# Access Compliance Report

## Public Rights-of-Way

Intersection ID: 20422	Main Street: W_ARROWWOOD_RD	Cross Street: S_TRYON_ST	Location: SW
ADA ID: DFA81E133A9E	Ramp Type: Perp	Initial Pass/Fail: Fail	Overall Compliance: No
Severity Score: 22.5			
Codes/Mitigation Info/Possible Solution		Field Measurements/Component Compliance

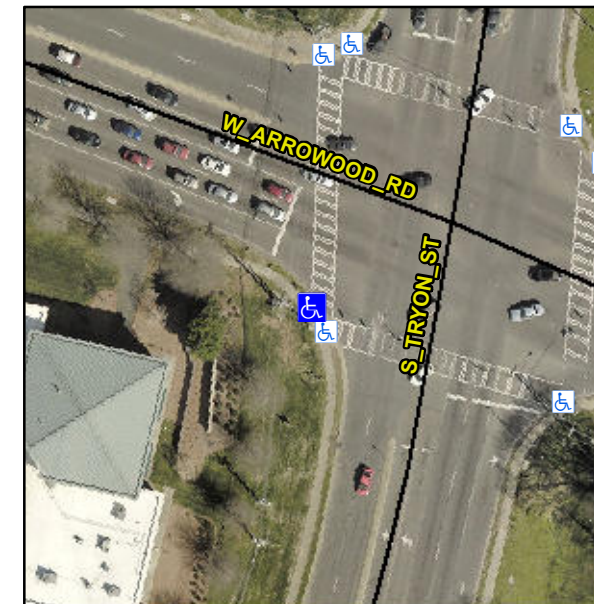
**Not Found, R304.5.1, R304.2.2**

Compliance	Description	Data	Compliance	Description	Data
N/A	Ramp Length (in)	75.0	No	Ramp Slope (%)	9.3
No	Ramp Width (in)	47.0	Yes	Ramp XSlope (%)	2.7
N/A	Flare Type LT	N/A	N/A	Flare Type RT	N/A
N/A	Flare Slope LT (%)	N/A	N/A	Flare Slope RT (%)	N/A
N/A	Flare Traversable LT?	N/A	N/A	Flare Traversable RT?	N/A
N/A	Landing Length (in)	N/A	N/A	DWS Provided?	N/A
N/A	Landing Width (in)	N/A	N/A	DWS Contrast?	N/A
N/A	Landing Slope (%)	N/A	N/A	DWS Length (in)	N/A
N/A	Landing X Slope (%)	N/A	N/A	DWS Full Width?	N/A
N/A	Landing Curb? (Y/N)	N/A	N/A	DWS Offset (in)	N/A
N/A	Shared Landing?	N/A			
N/A	Gutter Ponding?	N/A	N/A	Gutter Slope (%)	N/A
N/A	Gutter Lip Ht (in)	N/A	N/A	Gutter X Slope (%)	N/A
N/A	Painted X Walk1?	Yes	N/A	Painted X Walk2?	N/A
	X Walk 1 Direction	To N		X Walk 2 Direction	N/A
N/A	X Walk 1 Width (in)	132.0	N/A	X Walk 2 Width (in)	N/A
	X Walk 1 Slope (%)	0.5		X Walk 2 Slope (%)	N/A
	X Walk 1 X Slope (%)	3.4		X Walk 2 X Slope (%)	N/A

**Remove & Replace Entire Ramp.**
